| 2. AMENDMENT/MODIFICATION NO. A003 | 3. EFFECTIVE DATE May 23, 2012 | 4. REQUISITION/PURCHASE REQ. NO. | 5. PROJECT NO. (If applicable) | |
| 8. NAME AND ADDRESS OF CONTRACTOR (NO., street, city, county, State, and ZIP Code) | | X | 9a. AMENDMENT OF SOLICITATION NO. SHO800-Q-12-0030 | |
| 1. The purpose of this Amendment is to post the Questions and Answers. | | | | |

Site Plan (C002)

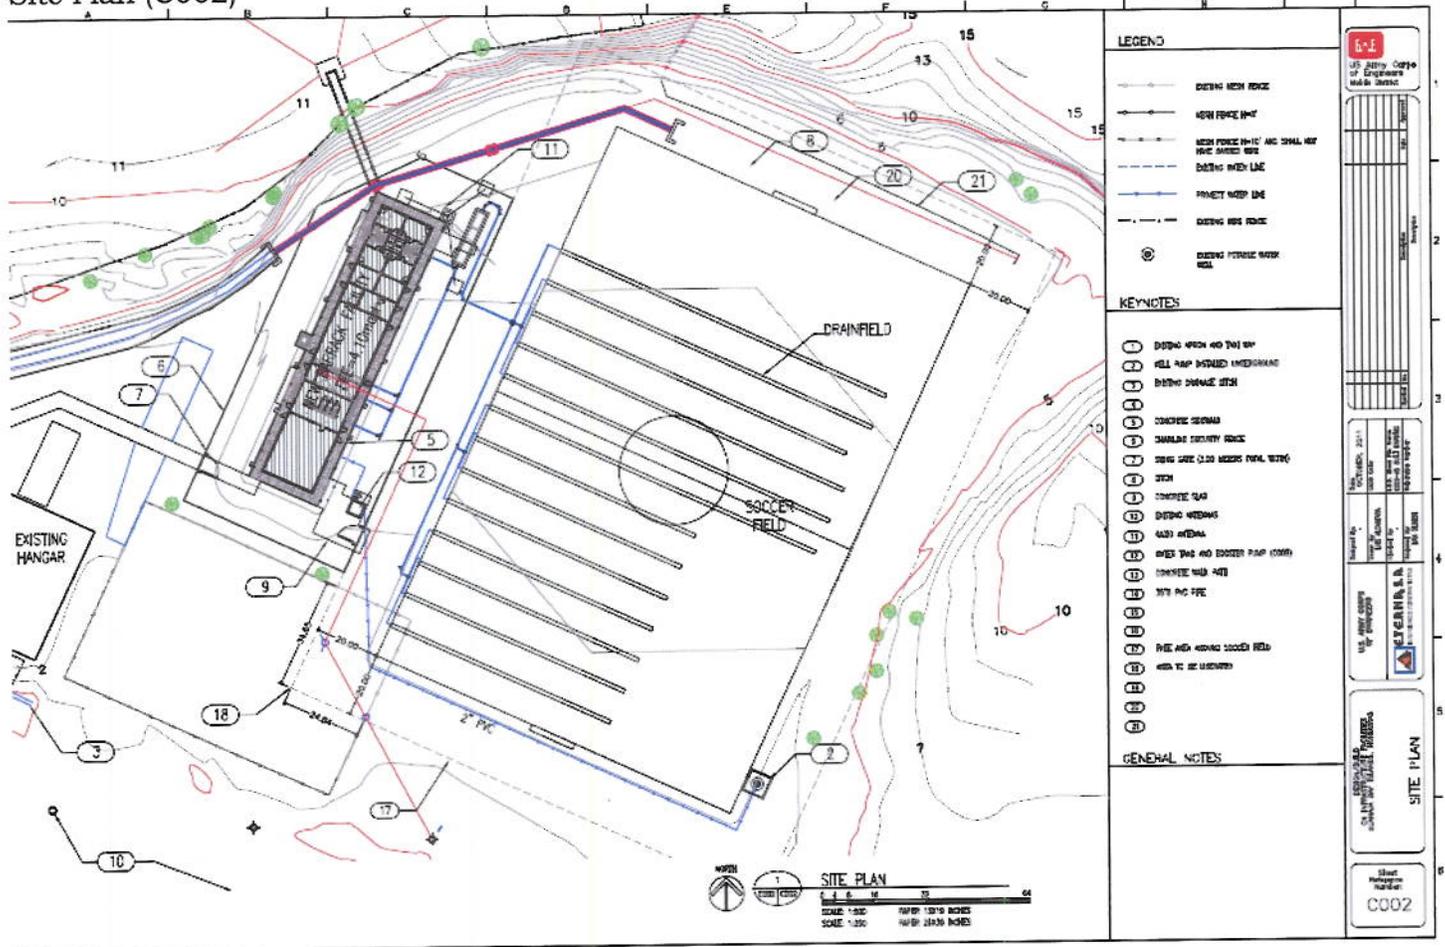
Q10) Transportation Requirements –

a) Please provide sketch or picture of the general area of the Naval Base
